Environmental Impact Report

580 California Street Office Building

FINAL 81.705E

Changes from the text of the Draft EIR are indicated by solid dots at the beginning of each revised section, paragraph or table. D REF 711.4097 F5857f

FIGURE 9: Office Projects Under Construction,

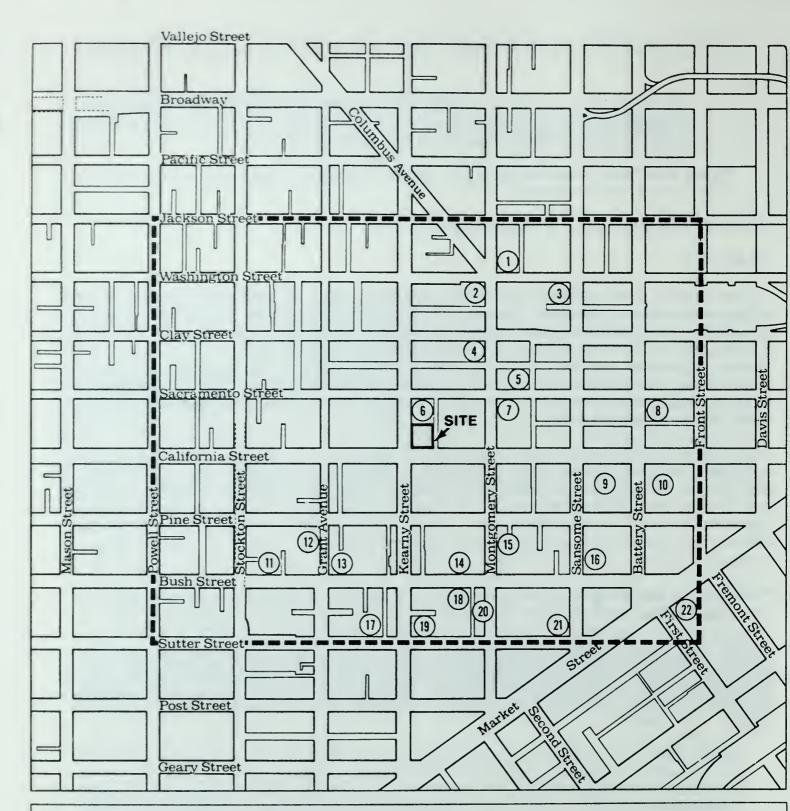
"[W]hat I really question is you don't have anything in here that deals with the explosion of office space and the explosion of activity on Kearny St. Kearny St. has had an awful lot of activity in the past two years. You have Crocker Center on it; you have San Francisco Federal Savings & Loan; you have another proposal on that same block. It think it's 222 Kearny, something like that. That is pending under review. You have the Kearny and Pine building, you have 550 Kearny, and you've got other buildings on Kearny that are still kicking around, including that conversion. I forgot the name of the furniture company that's the conversion on Sutter.

"The bottom line is that Kearny St., which used to be a mixed area, is becoming dominantly an area of very large, very massive office buildings, that is displacing retail uses and is changing the character of Kearny St., which is the nearest thing to a broad, sunlit street that you have downtown. It is just about the only street when you go up it to the north that has some sunlight on it. And you don't have anything in here that would indicate that there's been some things happening on Kearny St. I think you need to have it in here.

"It's a lot of square feet. It's three to four million sq. ft. off the top of my head, and that's probably an underestimate. So please put in here what's going on on Kearny St.

The conversion at Commercial and Montgomery, 569 Sacramento St. (81.610 ED) has been added to Figure 9. The conversion near Stockton and Sutter Sts., 44 Campton Pl. (82.870E), is not within the 3-block radius boundary shown in in Figure 9, p. 21 of the EIR. The conversion on Sutter St. is the Sloane Building at 216 Sutter St.; this has been added to Figure 9. In addition to these conversions, the following buildings have also been added to Figure 9: 736 Montgomery St.; 401 Washington St.; 582 Bush St.; 453 Grant Ave.; and 160 Sansome St. All of these developments were included in the analysis of cumulative effects contained in the EIR, but erroneously omitted from the graphic.

Figure 9 has been revised to show the relevant buildings, including conversions (see p. 21 and 125 of this document).
